SRK INDEPENDENT TECHNICAL REVIEW - CENTURY RESTART FEASIBILITY STUDY

Independent Technical Review

NCZ001

30 April 2018

Figure 4-1: Relationship Between Zn Concentrate Grade and SiO₂ Grade in Concentrate

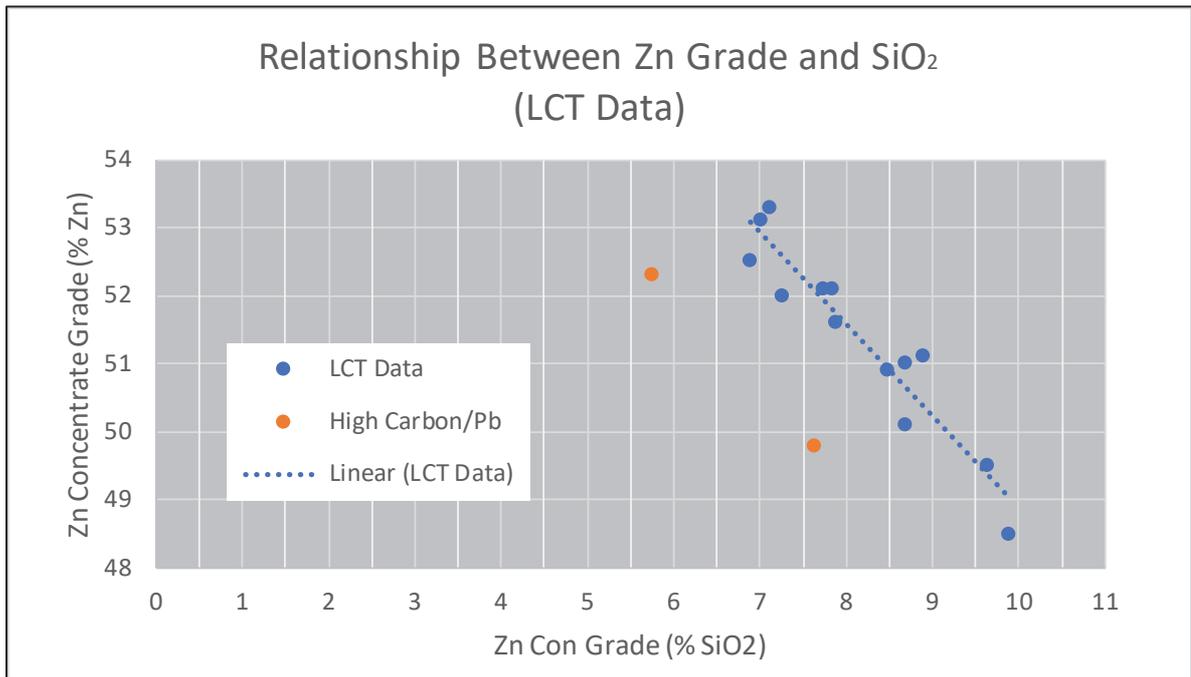
Locked cycle testwork has shown a concentrate product zinc grade, above 50% can be consistently achieved. The silica grade in this concentrate is elevated and inversely proportional to the zinc grade at nominally 7.0% to 9.2% at 52.0% and 50% zinc respectively. The higher the zinc grade, the lower the silica grade. This is presented in Figure 4-1. At a minimum zinc grade of 50%, based on this testwork, the silica is at levels that exceed some of the offtake agreement limits and at target levels, is at the high end of the desirable silica levels. This would incur penalties and at the upper end of the silica grade range and could present challenges in an oversupplied zinc market.

Piloting testwork is expected to provide further confidence in the product specification, particularly the zinc, silica and organic carbon grades are a key outcome of the pilot plant testwork. These results have not been formally reported yet, but the interim findings reviewed by SRK demonstrate that at a zinc grade of 50%, the silica has been maintained below 7% and does not present a risk to saleability under the executed offtake agreements.

Figure 4-3: New Century Zinc Summary Process Flow Diagram

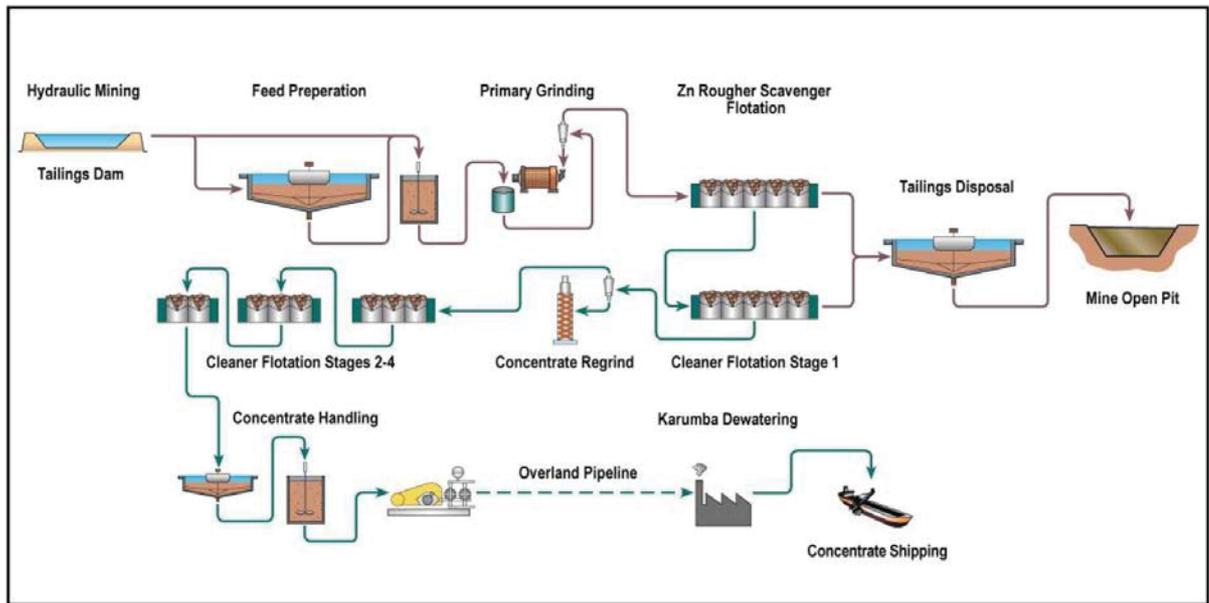
In SRK's opinion, the proposed processing flowsheet is appropriate, utilises the existing processing facility with additional modifications for the revised duty, reflects the flowsheet used for batch locked cycle tests and the pilot testing undertaken by NCZ. No critical issues have been identified.

In SRK's opinion, the proposed processing flowsheet is suited to the tailings tested. The concentrator process flow diagram is provided in Figure 4-3.

Figure 4-4: Production Ramp-up
 (Source: 171127-1 New Century Resources Model_v6 (Financial Model))

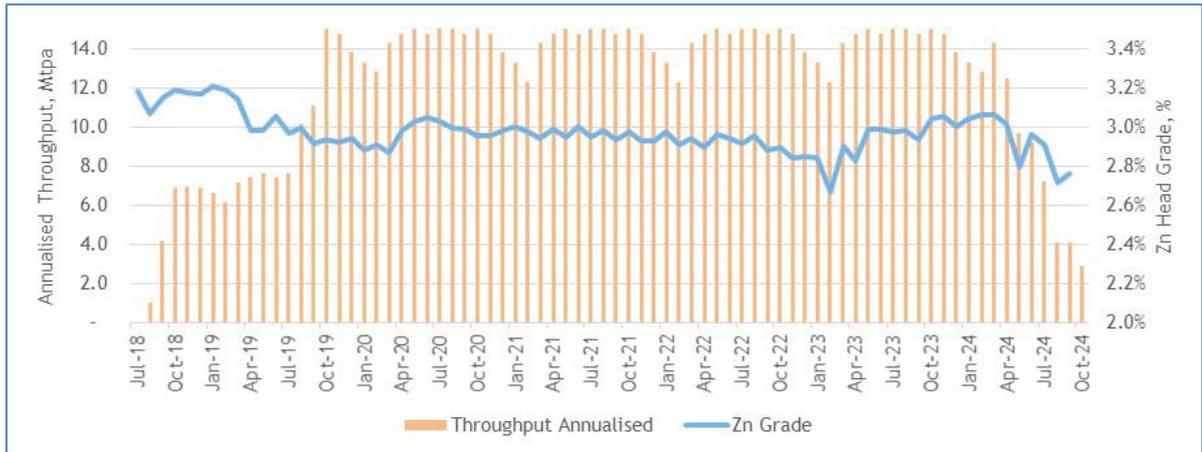
A production ramp-up period has been included in the financial model. This is based on the hydraulic mining production rate estimates as presented in Table 4-1 of the Feasibility Study report rather than the time that would typically be taken to ramp-up the processing facility. A 15% throughput is incorporated into Month 1 (August 2018) and 60% throughput in Month 2 (September 2018). Full Phase 1 production is achieved from Month 3 onwards, i.e. October 2018 to July 2019. SRK considers the first two months of production to be reasonable but recommends a ramp up of 90% through the process plant in the third month as a more conservative assumption, i.e. an additional month of ramp-up is recommended. This would allow for some additional delays to schedule and allow for 'teething' and debottlenecking issues to be addressed. While they may not be incurred, SRK would consider this to be normal. This is important on a restarted plant where there are often emergent areas of refurbishment that were not identified as part of the initial works. The early hydraulic reclaim of tailings is another factor to consider, i.e. a slower throughput ramp-up for Phase 1 and for Phase 2.

SRK considers it prudent to test the sensitivity of the financial model to a downside throughput at the Phase 2 design (i.e. less than 14.5 Mtpa) to assess the robustness of the Project.

Figure 4-6: NCZ Testwork Feed Grade, Concentrate Grade & Recovery Relationship

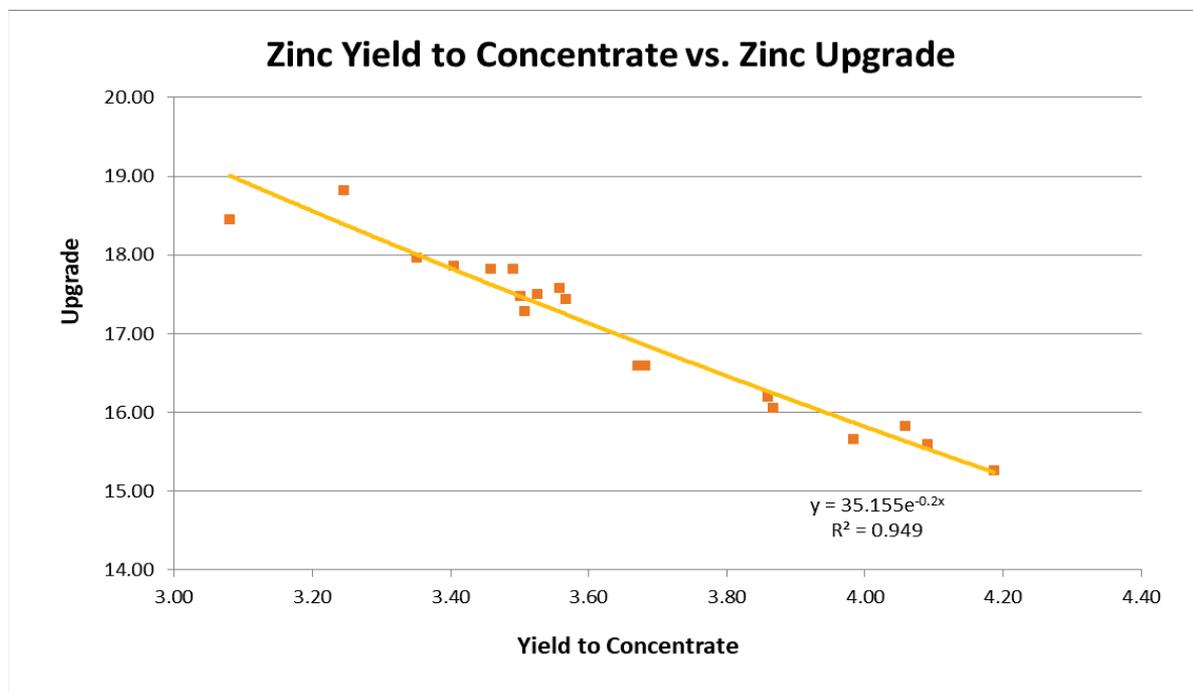
NCZ developed a zinc feed grade versus recovery relationship, however the correlation coefficient was poor. There is a small feed grade range and it is based on a single composite (made up of a large number of different drill holes and intervals) '1826 Master Composite 2' made up of 4.5 tonnes of drill core. The relationship is not sufficient to forecast grade versus recovery in the financial modelling, therefore an average recovery from the optimised tests have been used for forecasting purposes.

SRK accepts this was an acceptable option with the testwork data available, however, it has developed an alternative, multivariable relationship using feed grade, concentrate grade and recovery relationship (i.e. includes the concentrate grade) and incorporates the AM0023 domain testwork findings as well as the AM0016 composite sample testing. This has a much stronger correlation coefficient of 0.95 as shown below in Figure 4-6. This is a good relationship given the different test conditions and the limited number of tests and samples. SRK consider this to be superior to the average testwork recovery and have used this to adjust the likely zinc recovery and based on a LoM feed grade of 2.96% Zn and concentrate grade of 52.0% Zn (as per the financial model), it estimates a recovery of 61% rather than 62.5%. If the concentrate grade is adjusted to 51.0% Zn, testwork recovery increases in the relationship below to 61.5% and to 62% at a 50% concentrate grade.

Figure 4-7: New Century Zinc Restart Development Schedule

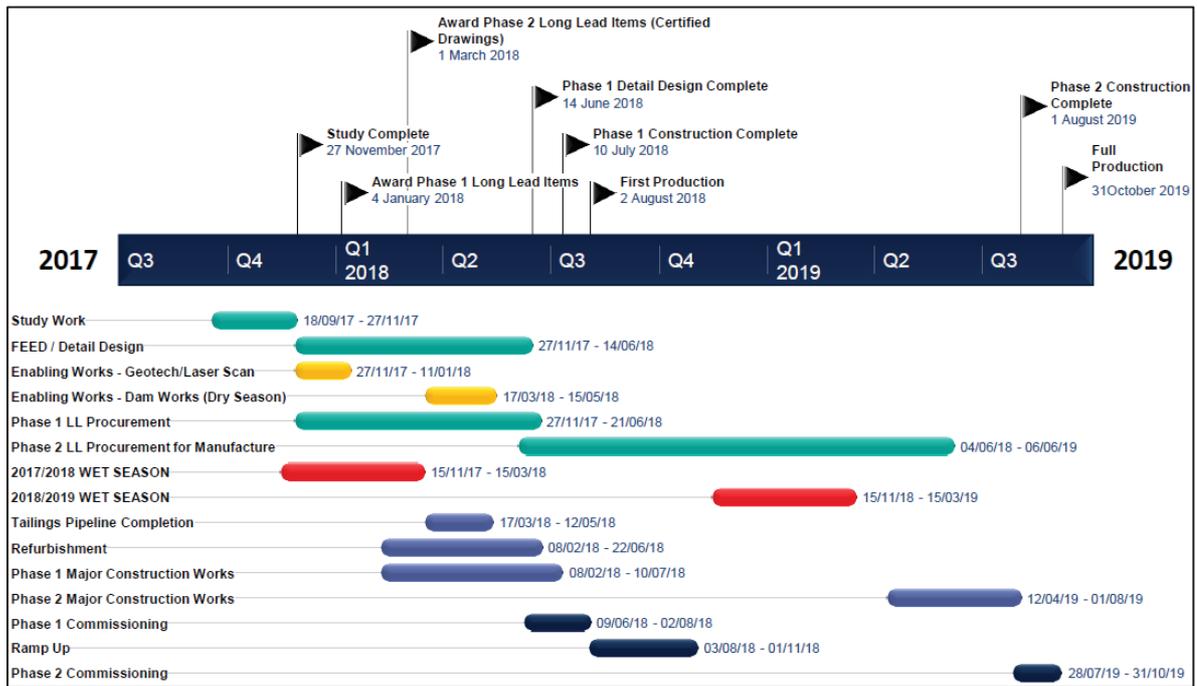
Although the Project benefits from the brownfield's nature of the plant, the good condition of the bulk of the plant and the reduced scope of work required, SRK considers the time allowed for the Phase 1 schedule to be best case. NCZ are aware of this and have acknowledged it in the Project risk register. There are several competing tasks on or near the critical path including; the new hydraulic reclaim system, structural steel fabrication and design and procurement of new equipment. Slippage in any one of them will be likely to delay practical completion. Poor performance of the EPC contractor and/or the owner's project management is another project schedule uncertainty, although with an EPC contract, the incentive is with the contractor to deliver on schedule, otherwise the contractor generally incurs (most of) the cost.

While an allowance of 19 days per year has been made for wet weather, no specific contingency has been allowed for schedule delays and there is likely to have already been some minor schedule slippage. Key milestones as presented by Sedgman 2017 and NCZ are shown in Figure 4-7.
